January 20, 2026

**Re: Comments and Contested Case Hearing Request Regarding Salado Creek Land Partners LLC and South Central Water Company's proposed wastewater direct discharge permit WQ0016658001**

Fig. 4: The Salado Creek Springshed, shown primarily in yellow above, fills dry Salado Creek with clear, cold water from the Edwards Aquifer (source: Clearwater Underground Water Conservation District).

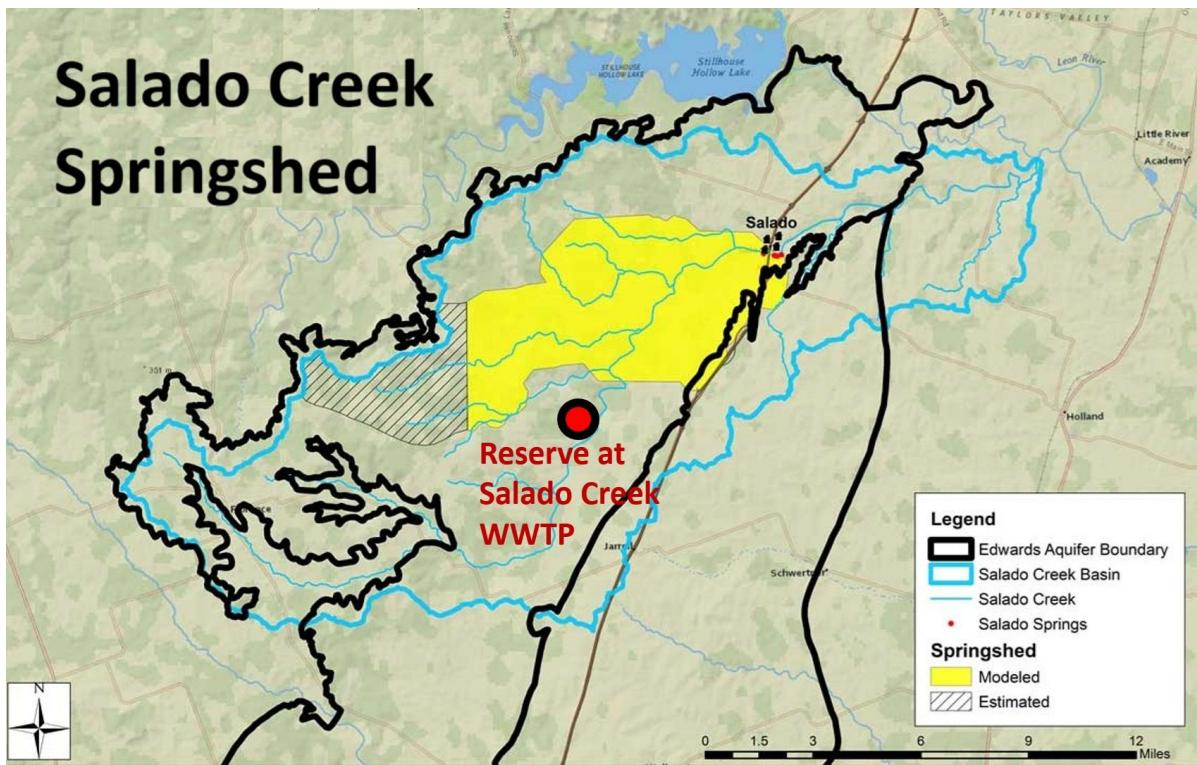
Just over a mile downstream (north) of the Reserve at Salado Creek's proposed treated sewage outfall area, the creek enters the Salado Creek Springshed. [The springshed is an area of numerous springs which convey water flow from the underground Edwards Aquifer to the surface of Salado Creek](#) (see Figs. 4 and 5).

The Salado Creek Springshed is one of the most environmentally-sensitive regions of Salado Creek and the entire Bell County as there is a two-way hydrological communication taking place within the springshed: precipitation and surface water flow to ground water through multiple recharge features, while numerous springs bubble up from the Edwards Aquifer to surface water/Salado Creek. Importantly, numerous private and public utility water wells are scattered around the springshed.

Fig. 8: A large number of water wells (shown as small purple circles) populate the area along Salado Creek between the proposed Reserve at Salado Creek WWTP and the town of Salado (source: Clearwater UWCD).

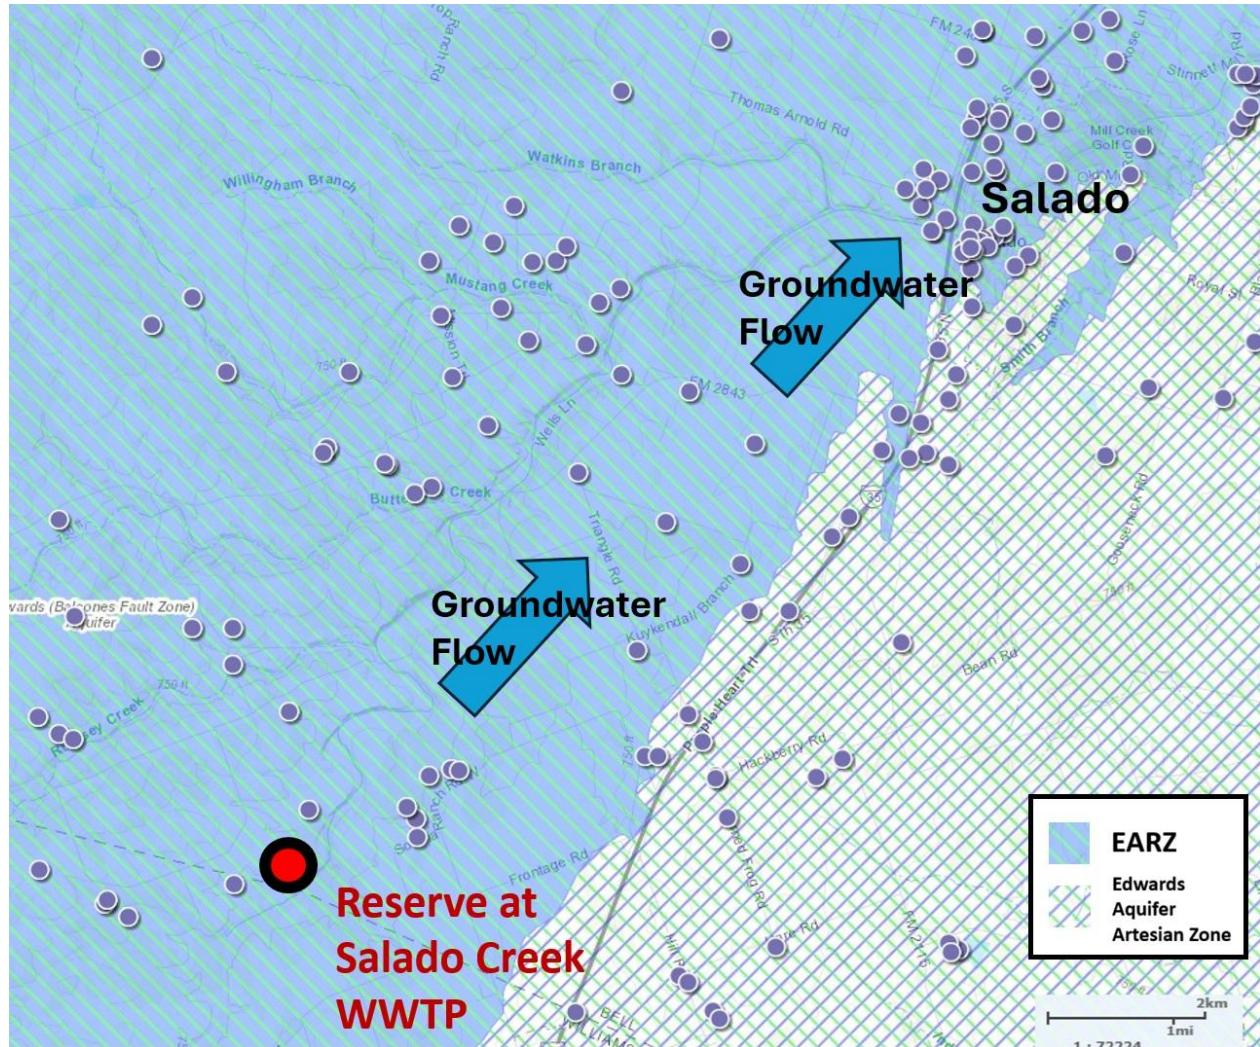
The proposed location for the Reserve at Salado Creek's wastewater treatment plant is in perhaps the worst possible location in terms of area well contamination potential, due to its location over the EARZ. The Edwards Aquifer groundwater in this area flows in roughly the same direction as Salado Creek, southwest to northeast, with both flows converging on the town of Salado (see Fig. 8).

Much of the effluent would then drain into the Edwards Aquifer through seeps, faults, and fractures, while the remainder would flow very slowly along the surface channel. Both surface water and groundwater would become simultaneously polluted with the accumulated amounts of Phosphorous, Nitrogen, solids, and bacteria present in the evaporating effluent stream.

Once the effluent enters the Salado Creek Springshed, it would mix with clear groundwater to create bacteria and nutrient-rich polluted springflows. From this point northward, both the surface water that local ranchers rely on to water their livestock and the groundwater residents rely on for

Fig. 10: Salado Creek between the proposed outfall location and the FM 2483 bridge inside the springshed has a very low slope, as the creek runs parallel to (and not across) the Balcones Escarpment to the west.

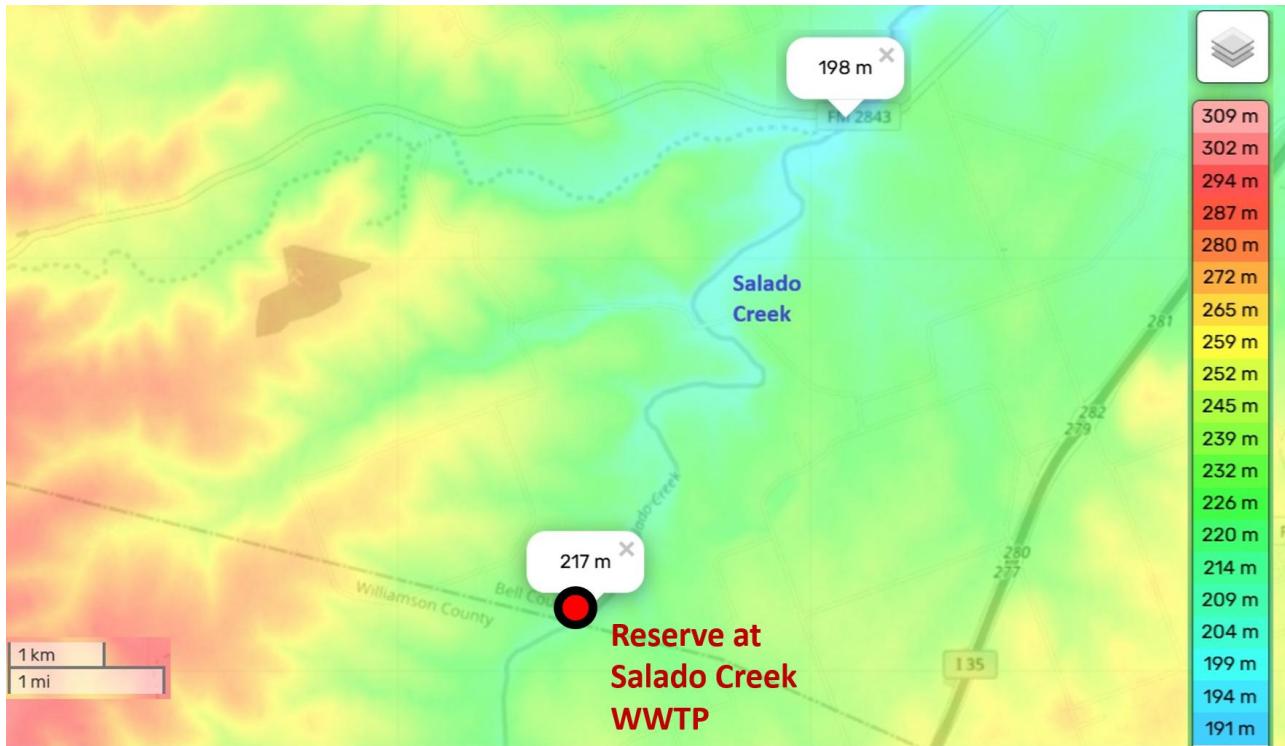
The slope of Salado Creek between the proposed Reserve at Salado Creek treated sewage outfall and the FM 2843 bridge 5.6 km downstream (5600 m) is just 0.34%, [inadequate to convey the flow of treated sewage](#)<sup>6</sup> (see Figs. 9 and 10). The slope calculation is as follows:

$$\begin{aligned}\text{Slope} &= (\text{Elevation at Outfall} - \text{Elevation at FM2843 bridge}) / \text{Distance} \\ &= (217\text{m} - 198\text{m}) / 5600\text{m} \\ &= 19\text{ m} / 5600\text{ m} \\ &= 0.34\%\end{aligned}$$

If the slope is less than this, pooling may take place in the channel, and the lower the slope, the greater the pooling. A slope of just 0.34%, which is just 1/6 of the recommended slope for adequate conveyance of water over land, would result in substantial pooling and the backup of treated sewage in the channel.

Fig. 12: TCEQ has authorized multiple direct discharge wastewater treatment plants without considering the cumulative impacts of treated sewage discharges on Salado Creek and the Edwards Aquifer.

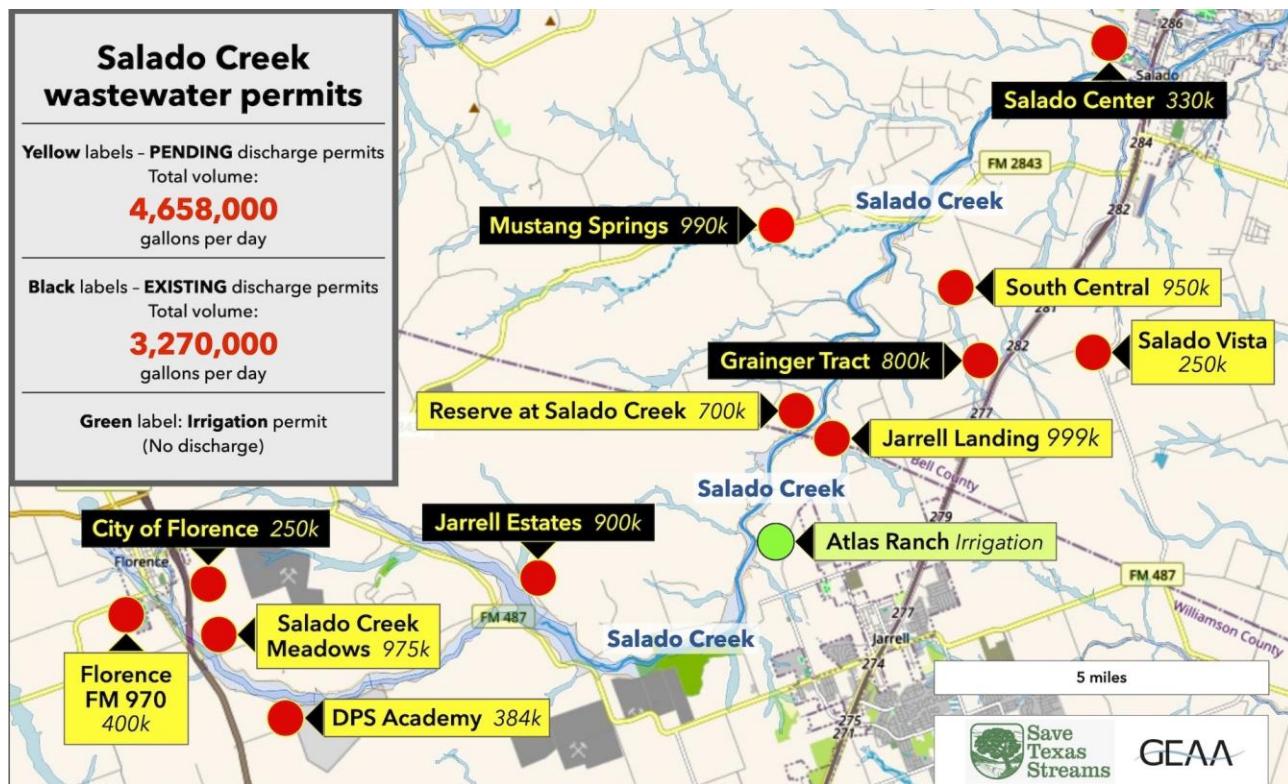
TCEQ is currently processing applications for 8 new permits that would allow treated sewage to be discharged into Salado Creek in Bell and Williamson Counties. TCEQ has previously approved four wastewater discharge permits on the creek. Most of the pending and existing permits are for wastewater treatment plants serving residential subdivisions near the towns of Florence, Jarrell, and Salado, a popular tourist destination (Fig. 12). The wastewater treatment plants for these twelve pending and existing permits could cumulatively discharge up to 8 million gallons of treated sewage into Salado Creek every day — a much higher volume than what’s discharged by most big-city wastewater treatment plants.

On page 63 of the TCEQ IPs, it states “The cumulative effect from multiple discharges... may require additional screening evaluation.”<sup>9</sup> Yet, despite the fact that many of these wastewater plants are in the EARZ, it appears that no additional screening evaluation has taken place. Instead, TCEQ has issued multiple permits for substantial treated sewage discharges with almost identical pollution limits and without regard to cumulative impacts of so many discharges in one watershed. Once again, the vague language in TCEQ’s IPs (“may require”) gives TCEQ cover to issue identical lax permit limits in a critically environmentally sensitive area, polluting Salado Creek and the Edwards Aquifer in the process.

Fig. 13: Jarrell Landing plans to run a 1.6 mile pipeline to discharge their 999,000 gallons per day of treated sewage at the exact same location as the Reserve at Salado Creek (source: JTX permit application)

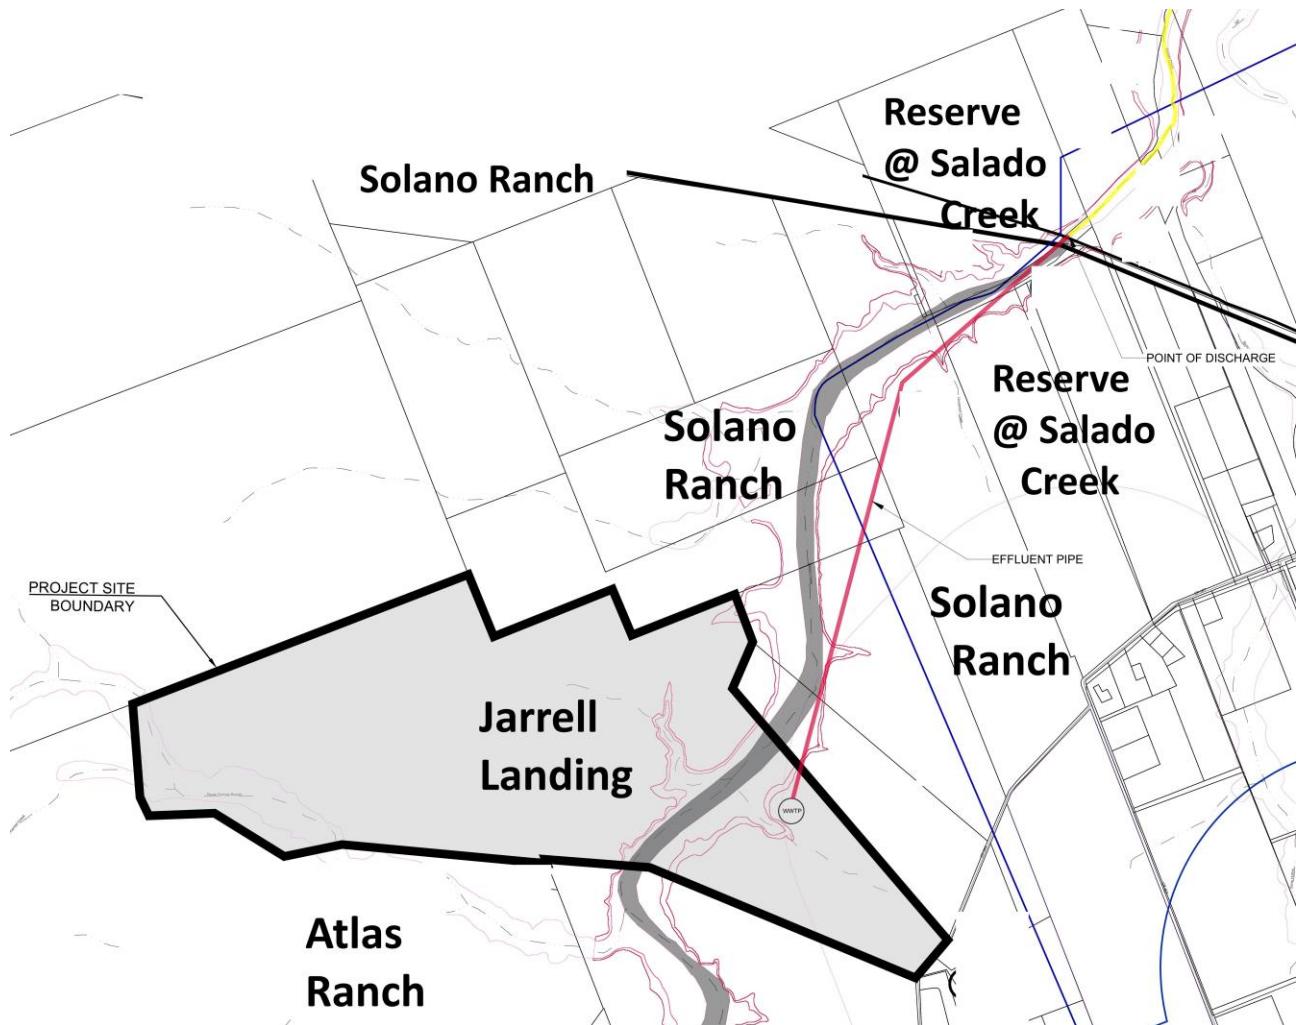
A closer look at the area immediately surrounding the proposed Reserve at Salado Creek tract reveals startling details. TCEQ has not only authorized the Reserve at Salado Creek to discharge up to 700,000 gallons per day of treated sewage at the property line of the contiguous landowner to the east, Michael Klepac - they’ve also authorized the Jarrell Landing development (permit number WQ0016207001) to run a 1.6 mile pipe to discharge that development’s 999,000 gallons per day of treated sewage at the exact same spot (Fig. 13). This would create a permanent effluent stream of almost 1.6 million gallons per day of treated sewage at a local landowner’s property line, where Salado Creek is dry most of the year.

It's clear why the Jarrell Landing developer wants the treated sewage discharge to occur as far away from their tract as possible; they don't want treated sewage discharge to foul the Salado Creek frontage in their development. What's unclear is why TCEQ would authorize such a dubious scheme that effectively combines large treated sewage discharges onto one spot at a local landowner's property line. After all, Jarrell Landing has almost a half mile of Salado Creek frontage where their effluent could be discharged. Why allow a 1.6 mile pipeline, which will more than double pollution/nutrient loads at a single combined discharge point on Salado Creek?

Fig. 17: Salado salamander monitoring locations are shown as red dots on the map. In 2024, numerous adult and juvenile salamanders were found in most of the locations shown.

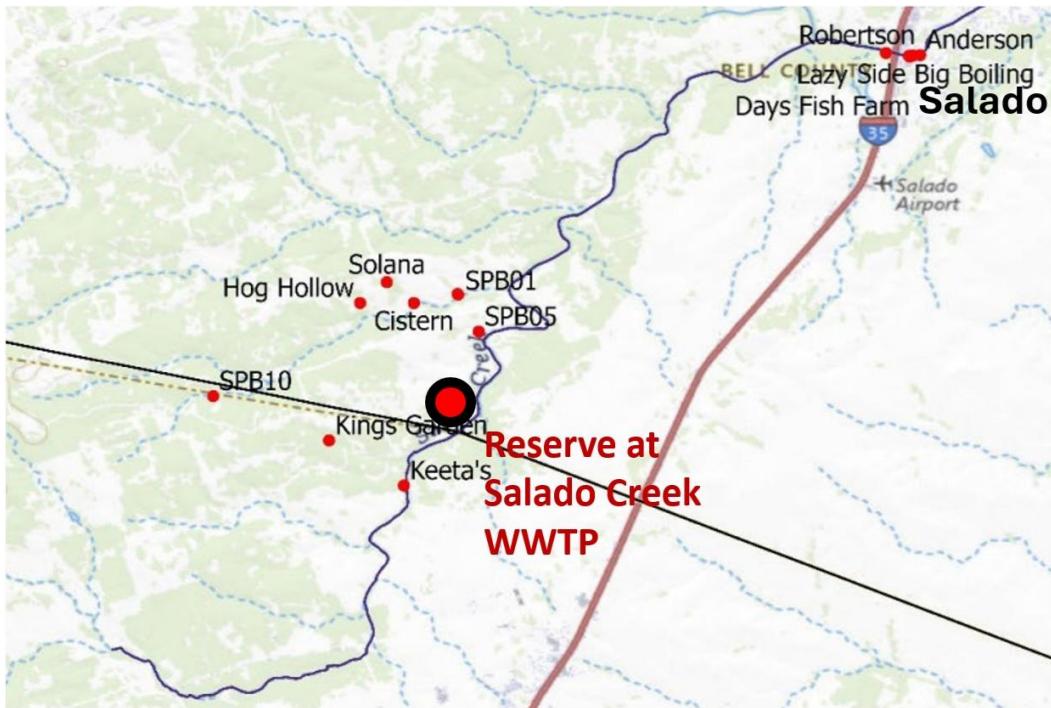
A total of approximately 1,315 acres of critical habitat was designated in Bell and Williamson Counties. Most of this land is sited in the area surrounding the Reserve at Salado Creek proposed outfall location. Fig. 17 shows the USFWS monitoring locations in relation to the proposed outfall location<sup>15</sup>.

Of particular concern is the negative impact on the productive Solana Ranch Springs Complex, shown in Fig. 17, to the north and northwest of the proposed wastewater plant less than 2 miles away.
